## **SERVICE KIT: #50**

**DATE ISSUED:** May 26, 2005 **Rev. A (revised 6-9-05)**

**SUBJECT:** 802 Air Tractor Float Longeron and Float Bracket Repair

**MODEL:** Floated AT-802 Air Tractors

Option A  
Figure 2

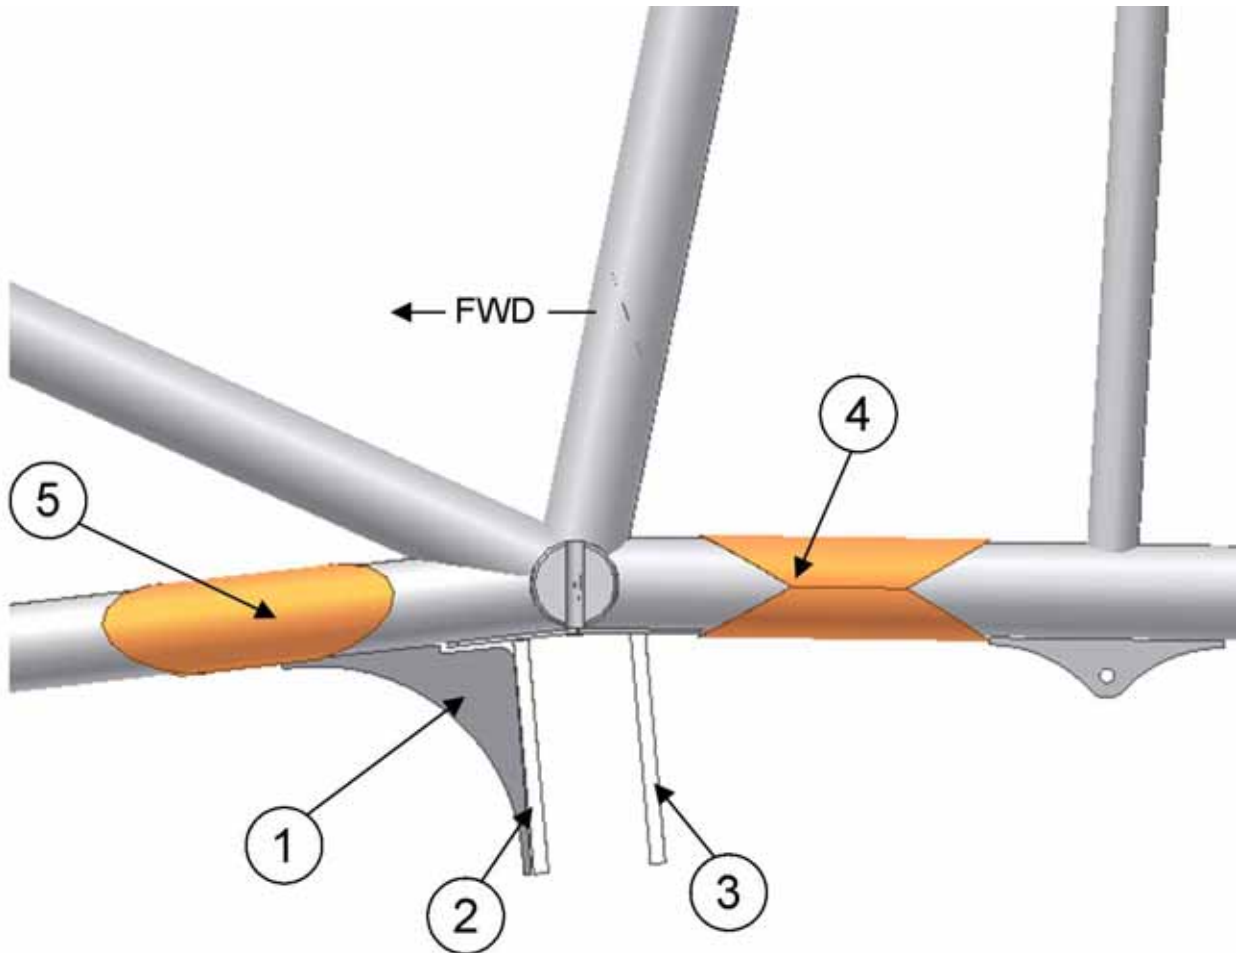
1. Remove floats.
2. Drain fuel.
3. Remove fairings and fuel selector valve.
4. Plug all hoses and fuel openings.
5. Clean and dry all fuel from the area.
6. Cut openings in fairings and fabricate new screw-on covers or use Service Kit #51.
7. Remove Aluminum float attachment block.
8. Reshape both front and rear gussets as shown in Option A or Option B using drawings p/n 10A02491-006 and 10A02491-005 as a pattern.

With Option A the rear gusset is completely removed.

9. Strip paint in all areas requiring welding or stress relieving.
10. Fill fuel tanks or provide other means of safety for welding near fuel tanks.
11. Fit rear sleeves into place and then trim one side of sleeve to maintain ½ inch clearance from Tube 2 (Fig. 3, Area 1) Add sleeves (Wipaire p/n 1001536 or Air Tractor p/n 11072) and weld onto longeron (Fig. 2, area 5).

12. If cracks were found in Area A of Figure 2 in Service Letter #71, fit front sleeves into place (Option A, Air Tractor p/n SK574-3) and weld onto longeron.

Figure 4

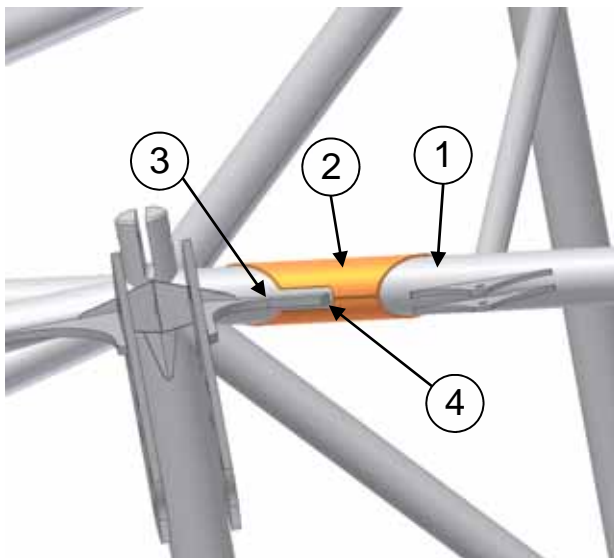
13. If cracks are found on the ends of the attach plates (Fig. 4, area 4), cut the attach plates back to a location over the bottom doubler on the cluster (Fig. 4, areas 1 & 4). Re-weld attach plates to the doubler and wrap the weld around the inside ¼ to ½ inch.
